## HISTORIC AND DESIGN REVIEW COMMISSION

November 15, 2017

**HDRC CASE NO:** 2017-576  
**ADDRESS:** 222 W GUENTHER ST  
210 NATHAN  
**LEGAL DESCRIPTION:** NCB 2973 BLK 5 LOT 1  
**ZONING:** RM-4,HS  
**CITY COUNCIL DIST.:** 1  
**DISTRICT:** Nathan Historic District  
**LANDMARK:** House  
**APPLICANT:** Robert Murray  
**OWNER:** Robert Murray  
**TYPE OF WORK:** Rehabilitation, rear addition, demolition of an accessory structure, construction of an accessory structure, window replacement, exterior modifications and Historic Tax Certification  
**APPLICATION RECEIVED:** October 27, 2017  
**60-DAY REVIEW:** December 26, 2017  
**REQUEST:**

The applicant is requesting a Certificate of Appropriateness for approval to perform exterior modifications to the structures at 222 W Guenther and 210 Nathan, both of which are located on one parcel.

210 Nathan Proposed addition S

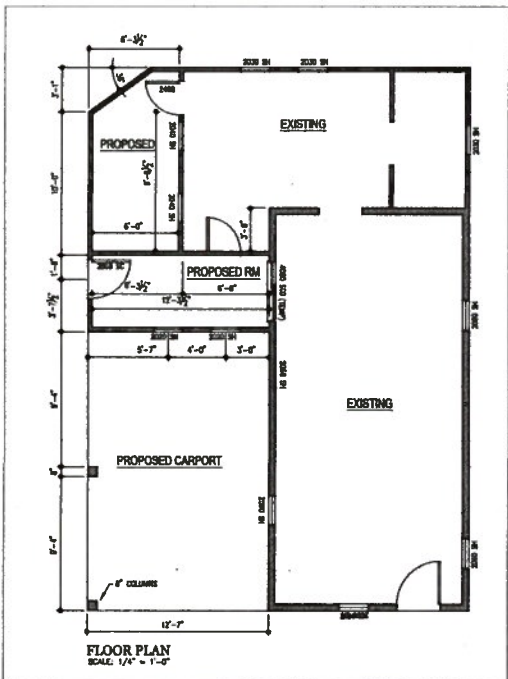
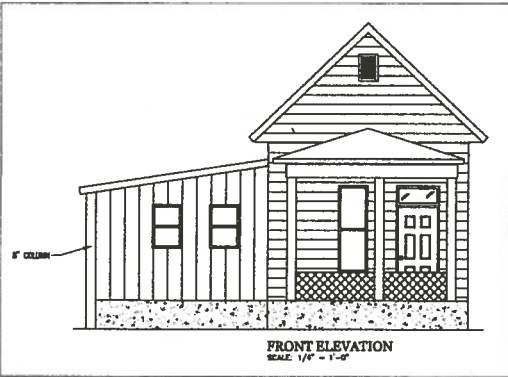
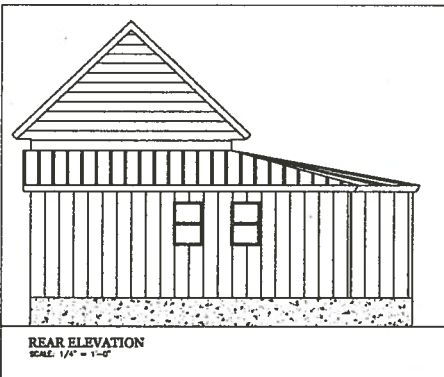
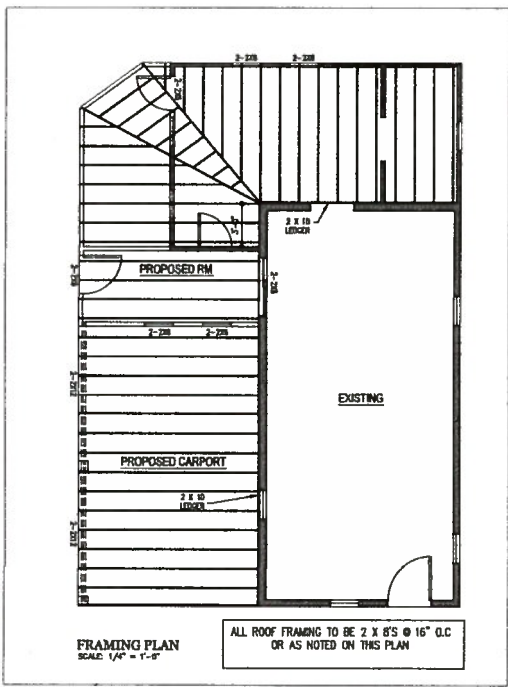
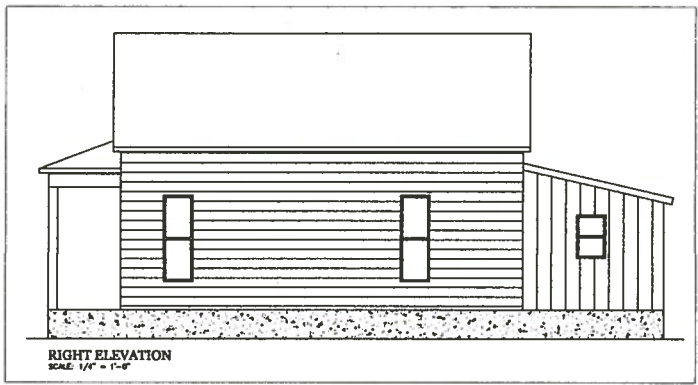
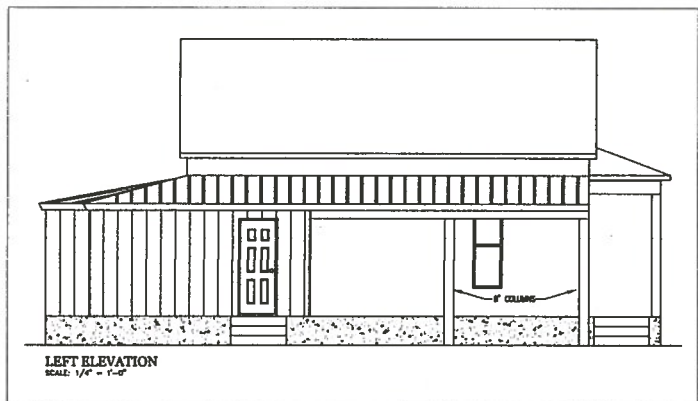
- e. **ADDITION** – The applicant has proposed to construct a side addition to the historic structure at 210 Nathan to feature an extension of an existing rear and side addition. The applicant has proposed an overall addition of approximately 120 square feet. The Guidelines for Additions 1.A. states that additions should be sited to minimize visual impact from the public right of way, should be designed to be in keeping with the historic context of the block, should utilize a similar roof form and should feature a transition between the old and the new. Staff finds that the proposed addition is generally sited in a location that does not detract from the historic forms of the shotgun house.

- f. **SCALE, MASS & FORM** – Regarding scale, mass and form, the applicant has proposed an addition that generally features a footprint and height that are appropriate and consistent with the Guidelines.

- g. **MATERIALS** – The applicant has proposed materials that include a standing seam metal porch roof, horizontal siding and vinyl windows. Staff finds that roofing materials that match those of the primary historic structure should be installed and that siding for the proposed addition should match that of the primary historic structure. Staff finds that windows should be wood to match the profile of the historic wood windows found in the structure.

- h. **CARPORT ADDITION** – The applicant has proposed to construct a carport addition to the historic structure at 210 Nathan that is to extend to the front of the historic structure. Staff does not find this to be appropriate nor is it consistent with the Guidelines for Additions 1.A.i.

5 – Staff recommends approval of item #5, the construction of a rear addition with the following stipulations:

- i. That the proposed carport is eliminated from the request.
- ii. That wood or aluminum clad wood windows should be installed that feature meeting rails that are no taller than 1.25” and stiles no wider than 2.25”. White manufacturer’s color is not allowed, and color selection must be presented to staff. There should be a minimum of two inches in depth between the front face of the window trim and the front face of the top window sash. This must be accomplished by recessing the window sufficiently within the opening or with the installation of additional window trim to add thickness. Window trim must feature traditional dimensions and an architecturally appropriate sill detail. Window track components must be painted to

- match the window trim or concealed by a wood window screen set within the opening.
- iii. That the addition feature roofing, siding and skirting materials to match that of the historic structure.
